Sacramento Suburban Water District/Del Paso Manor Water District 2x2 Ad Hoc Committee

Agenda Item: 2

Subject: Del Paso Manor Water District Meter Recommendation

Subject: Safety Condition Assessment

3601 Kings Way – 6 inch meter assembly

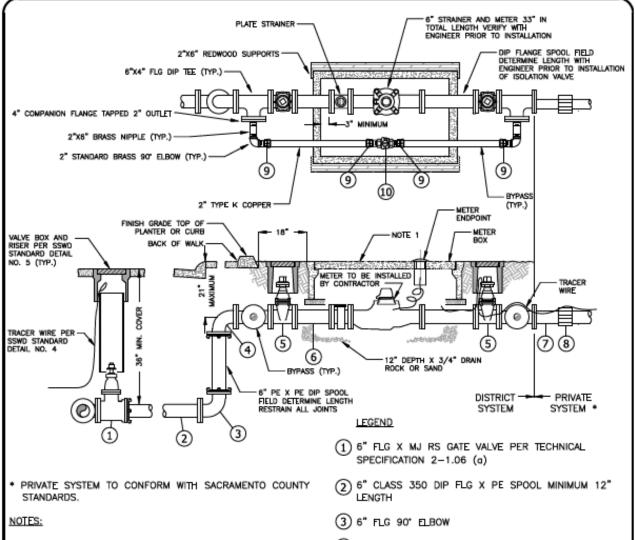
- Meter Specification 6-inch Sensus compound meter that is obsolete and has not been supported by Sensus since 2011. Parts are not available to make repairs.

- Meter Configuration
 - o The meter has an oddball lay length and is 2 inches shorter than a standard 6-inch compound meter.
 - O The meter is installed on the customer owned backflow assembly plumbing and is bolted directly onto a 90-degree elbow (Attachment 1). This is not an approved installation as per AWWA Standard C702-15 Section A.8: Installation, which refers to the manufacturer's installation instruction manual that states, "When installing the meter with a Plate Strainer, a minimum of 5 pipe diameters of straight, unobstructed pipe is required upstream of the meter. This allows for dampening of velocity profile distortions caused by items such as elbows, pumps and dirt traps upstream of the meter." The current installation will definitely effect meter accuracy.

- There is no meter strainer. Meter strainers are designed with an internal screen that protects the measuring elements of the meter by preventing debris from passing through the meter. They also help reduce water turbulence that effects meter accuracy.

- o The meter does not have a by-pass. The by-pass allows for meter testing without interrupting water service to the building. This is important because the building has cooling towers and boilers.
- o This type of commercial meter should be tested on an annual basis.
- Volume of Water Registered 56 million gallons of water have passed through the meter since installation, based on the current meter read. This does not include the unaccounted water due to meter inaccuracy.
- Service Connection Inspection Staff attempted to schedule a field visit with Ken Ingle
 to turn the meter off to confirm what it serves. The visit would have been coordinated
 with the building Engineer to avoid damaging the cooling towers and boilers. Ken Ingle
 stated the meter was showing monthly usage so the priority was the meter at 3542 Kings
 Way.

Meter on backflow preventer assembly

Obsolete 6 inch compound meter

- Remove meter from the backflow assembly and install the meter assembly as per SSWD Standard Detail No. 18 (Attachment 2), which is consistent with AWWA standards.
- Replace the current obsolete meter with an AMI compatible 6-inch compound meter.
- 6-inch meters are considered high revenue meters and should be tested annually to ensure an accurate revenue stream.

3542 Kings Way – 3-inch meter assembly

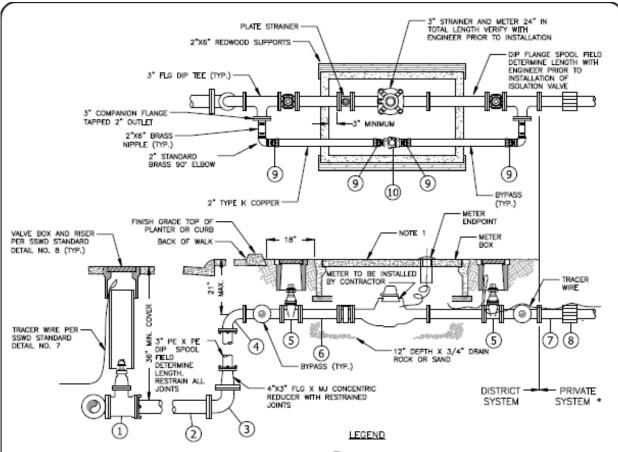
- Meter Specification 3" turbine meter, which is the wrong application for this type of service. Turbine meters are designed for high flow applications such as irrigation systems at parks and manufacturing plants. Turbine meters do not capture flows below 4-5 gallons per minute (gpm).

- Meter Configuration
 - o The meter has no test port; therefore, it cannot be tested in the field.
 - o There is no meter by-pass for testing.
 - O There is no meter strainer. Meter strainers are designed with an internal screen that protects the measuring elements of the meter by preventing debris from passing through the meter. They also help reduce water turbulence that effects meter accuracy.

- O As per the previous notes above, this meter is also installed on the customer owned backflow assembly plumbing and is bolted directly onto a 90-degree elbow (Attachment 3). This is not an approved installation.

Meter on backflow preventer assembly

3-inch turbine meter

- Remove the meter from the backflow assembly and install the meter assembly as per SSWD Standard Detail No. 16 (Attachment 4), which is consistent with AWWA standards.
- Replace the current turbine meter with an AMI compatible 3-inch compound meter. 3-inch compound meters are accurate down to ½ gpm.
- Test the meter on a 3-5 year cycle depending on annual usage.

20-10 CONTROL OF HAZARDOUS ENERGY

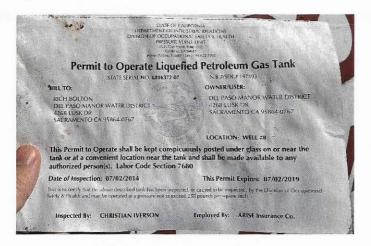
Issue: The gate valve is not locked out or correctly tagged out.

Recommended Solution(s): Use an appropriate lockout procedure, device (i.e., valve cover or chain), unique identifiable lock, and appropriate tag to lockout the valve. This will prevent the unintended opening of the valve, while service and testing are being performed.
